Southern Utah
Fuel Company
P.O. Box P
Salina, Utah 84654
(801) 529-7428
(801) 637-4880 (Mine)

May 8, 1985

SUBJECT: SUBSTATION MODIFICATION

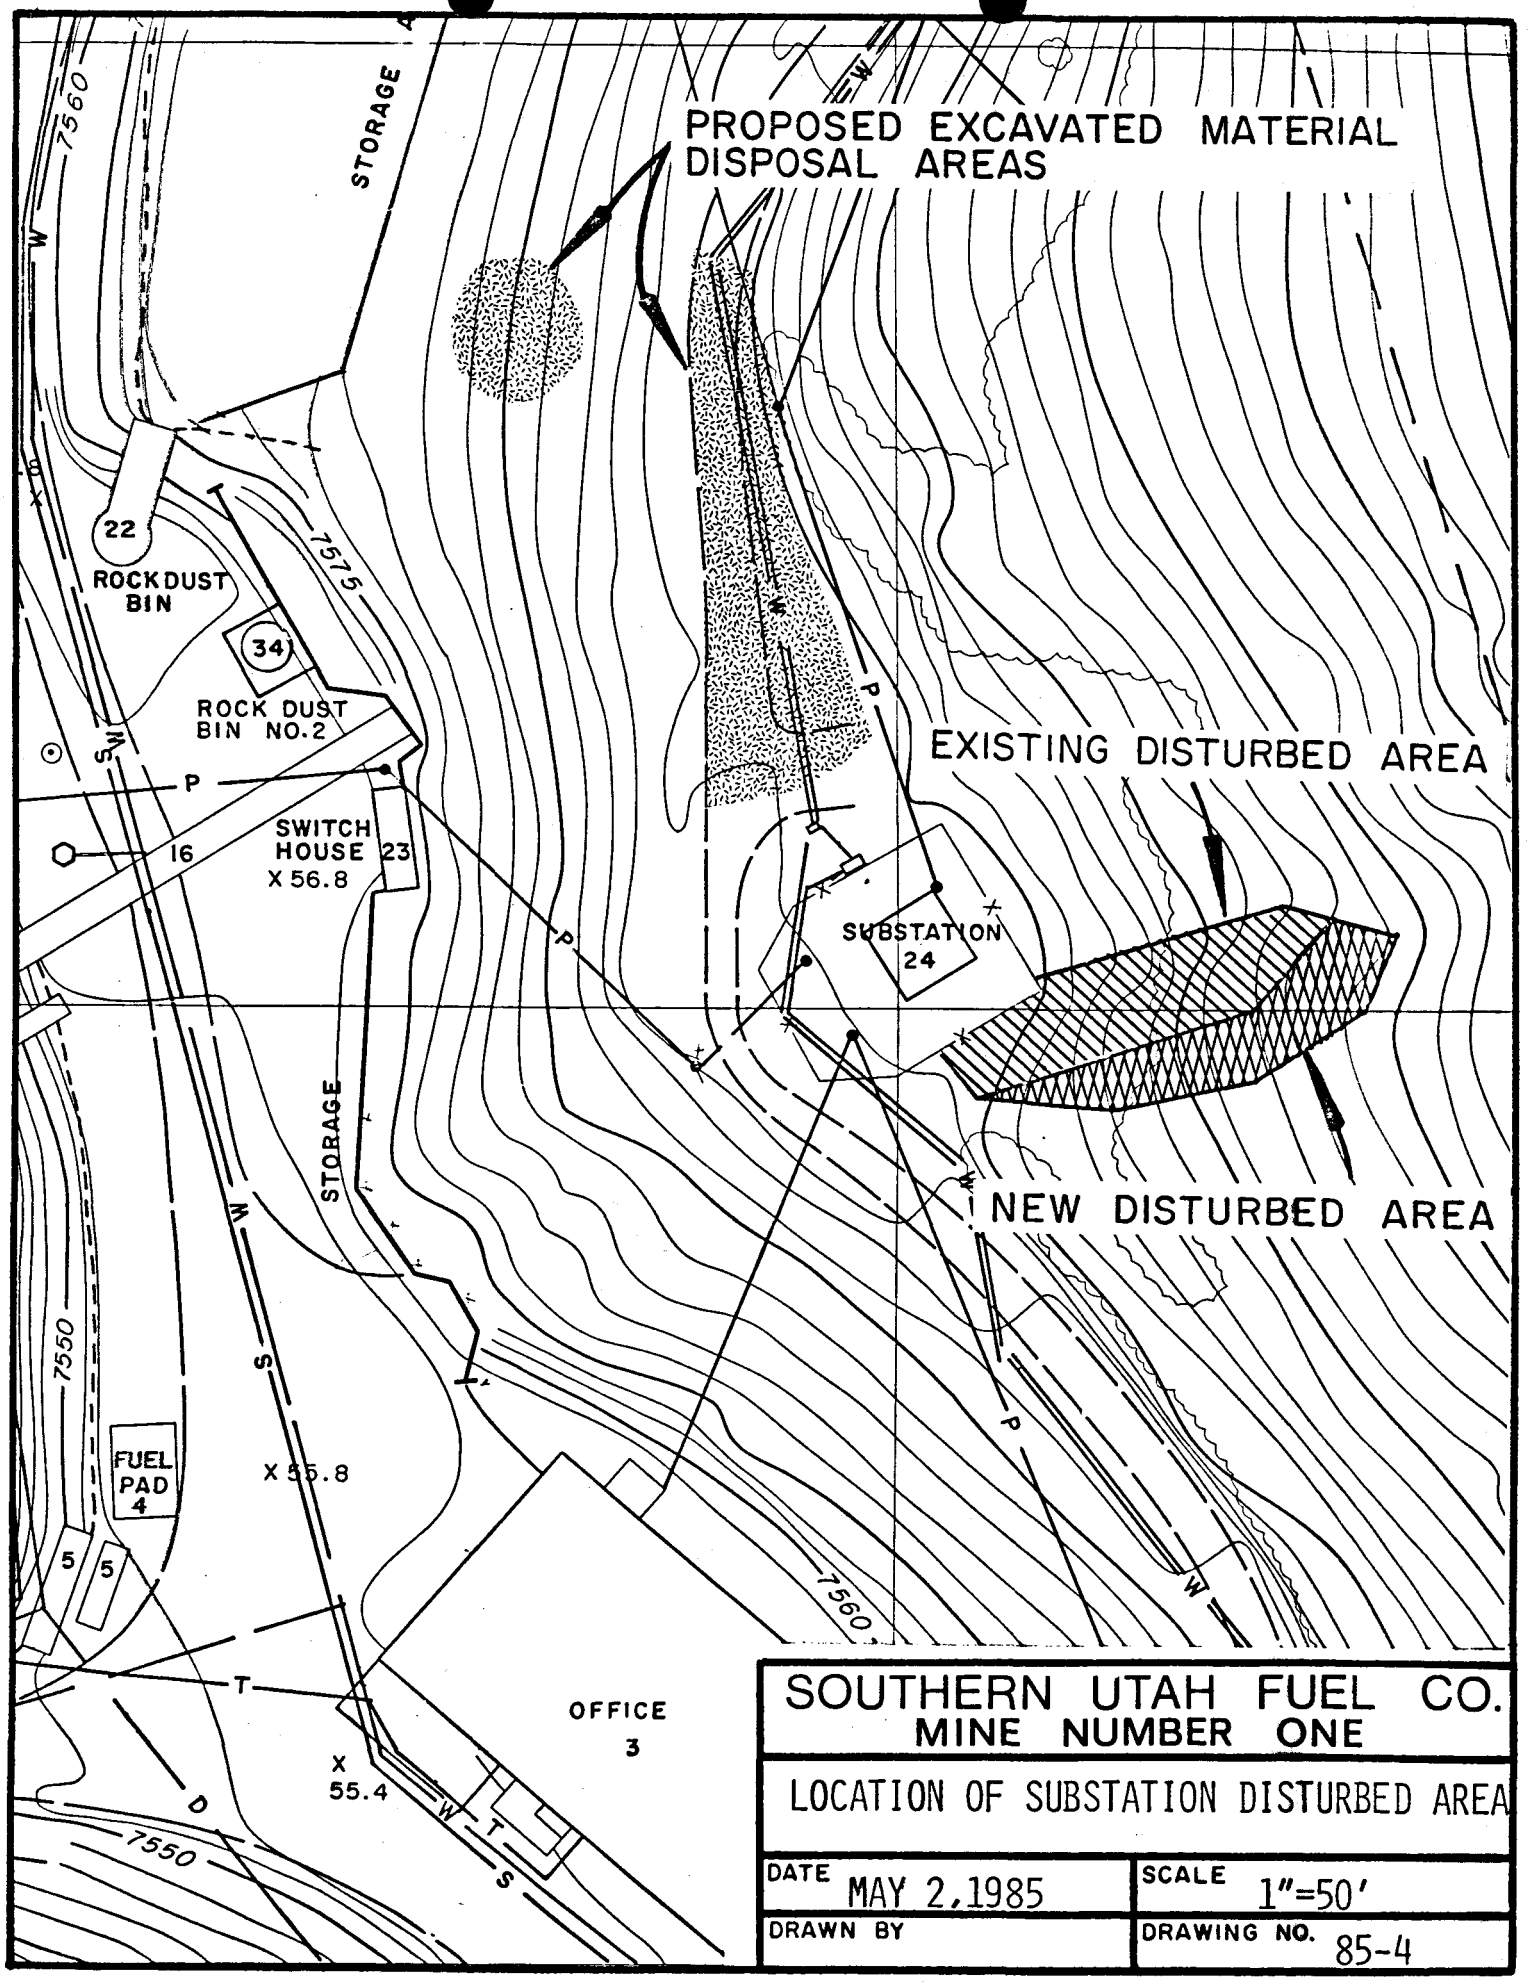
The modification project will consist of replacing the existing 25 kV/12.5 kV transformer with a 69 kV/12.5 kV transformer and expanding the existing fenced perimeter to gain required safety clearances. In addition, a grounding grid will be buried inside the fence and eight feet outside the conductive segments of the fence to conform with Utah Power and Light Company's current substation safety requirements (drawing 85 Elect 114B). The total area affected is within the disturbed area previously calculated for bonding and is shown on the enclosed topographic map number 85.4.
